Title		
Phoenix Theremin 2020 - Front panel		
Size	Number	Revision
A4	Humorous words of wisdom ...	1.07.19A
Date:	21. 01. 2019	Sheet of
File:	H:\FAKS\...FrontPanel.SchDoc	Drawn By:

Title			
Phoenix Theremin 2020 - Pitch board, audio section			
Size	Number	Revision	
A4	... from our faculty:	1.07.19A	
Date:	21. 01. 2019	Sheet	of
File:	H:\FAKS\...PitchBoard - AudioSection.Sch

Title		
Phoenix Theremin 2020 - Pitch board, RF section		
Size	Number	Revision
A4	Theoretically speaking, ...	1.07.19A
Date:	21. 01. 2019	Sheet of
File:	H:\FAKS\...PitchBoard - RF_Section.Sch	Drawn By:

Title		
Phoenix Theremin 2020 - Volume board, RF section		
Size	Number	Revision
A4	... the same thing.	1.07.19A
Date:	21. 01. 2019	Sheet of
File:	H:\FAKS\VolumeBoard - RF_Section.SchDown By:

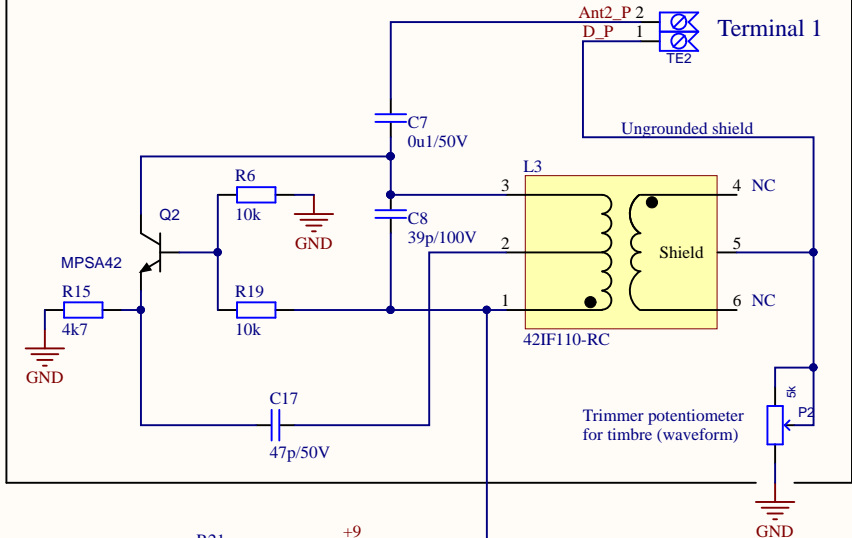
How should I name the connector in the place of Ant2_P? This is the marking I see on the website.

P2 and P3 are used to balance thermal drift they are not mandatory however and may be left out, as they will be bypassed by R9 and R27.

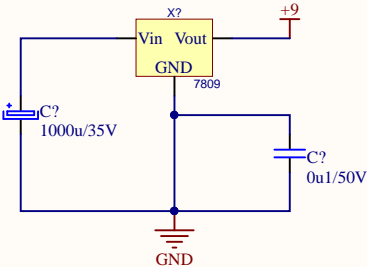
I still see this and it doesn't look right to me.
Did you forgot to reupload a new image
Or is this intended?

FIDUCIAL MARKS -
they play no role in how the circuit works whatsoever.
They are used if anyone intends to send gerber files to a company that produces printed circuit boards so the machines that etch the board (and possibly place the parts) can orient what is their position over the board.

They are seen in the corners of the PCB, placed on top (red) side.

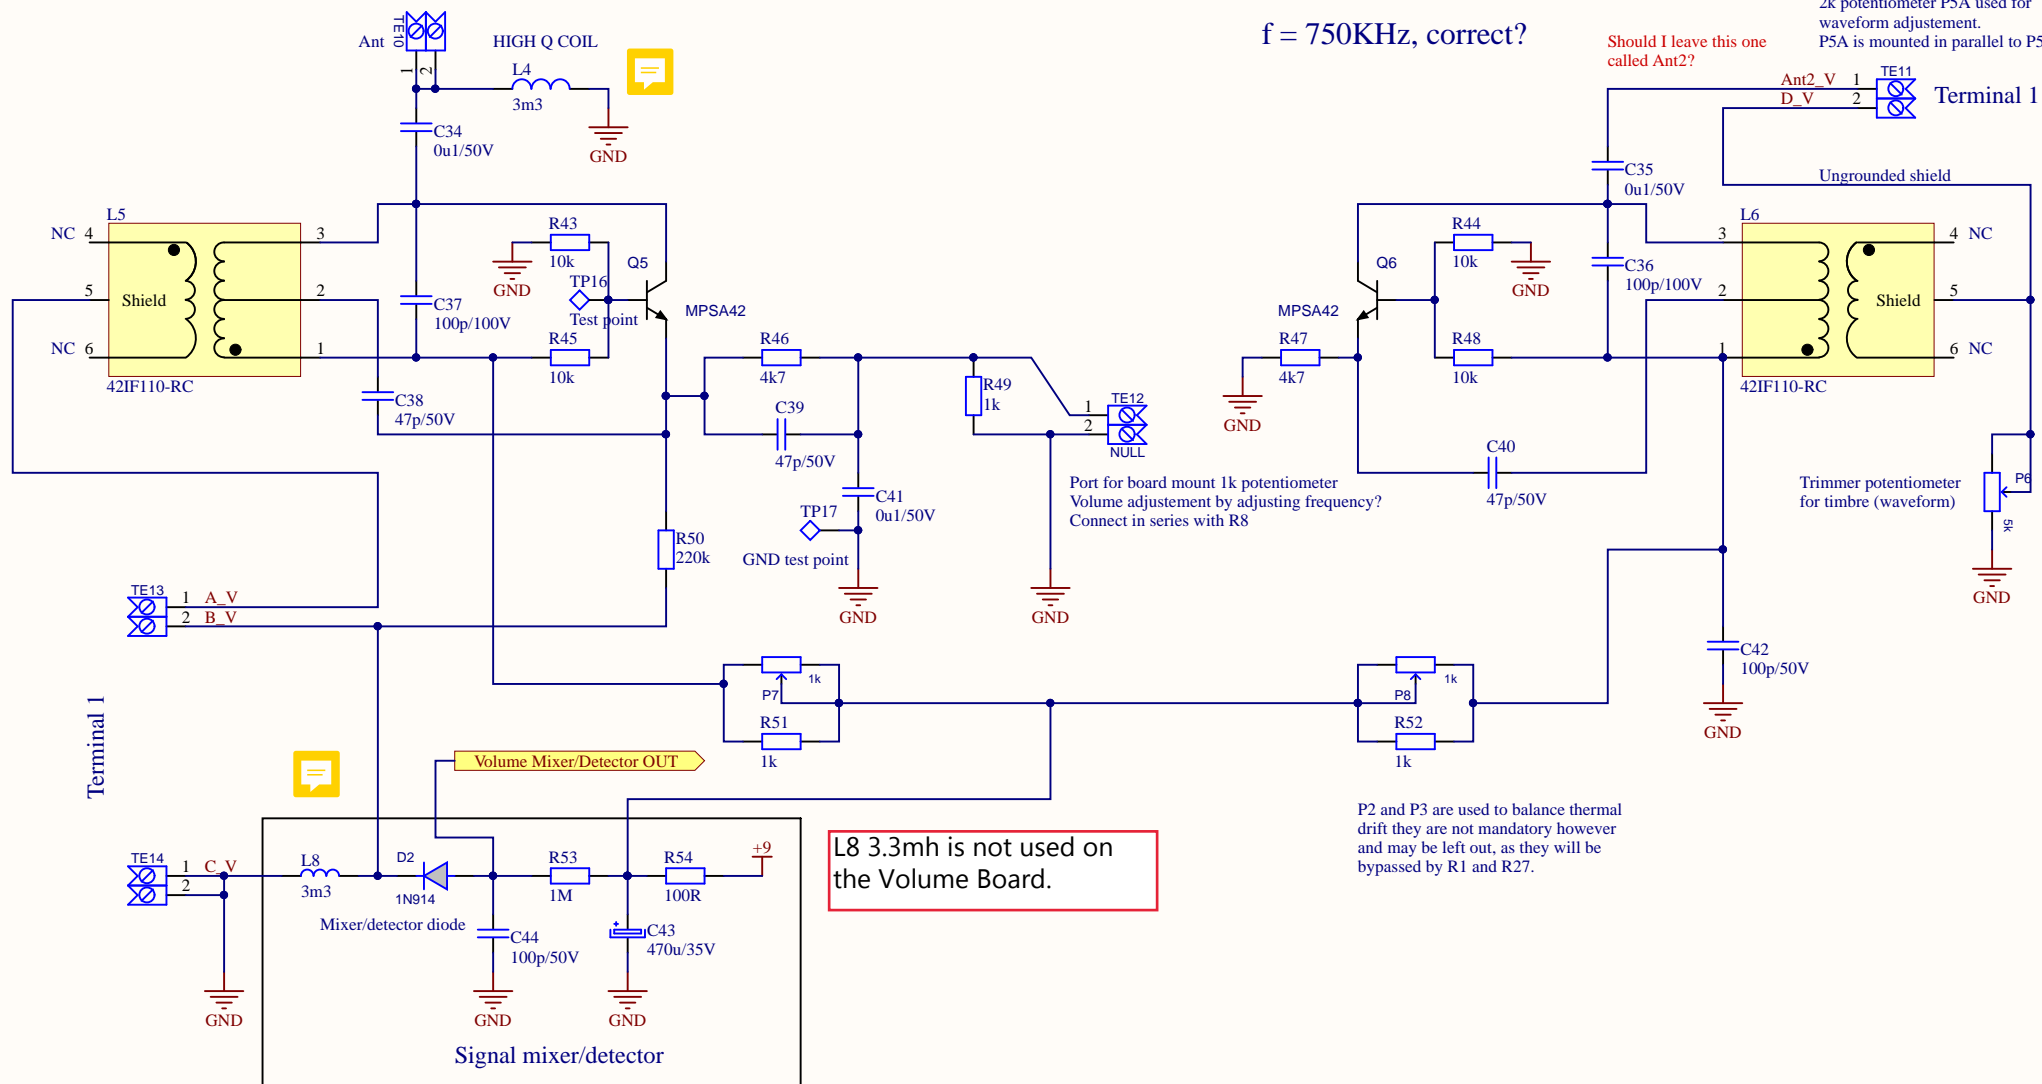
L4 3.3 mh is not used on the Volume Board.

$f = 750\text{KHz}$, correct?

Should I leave this one called Ant2?
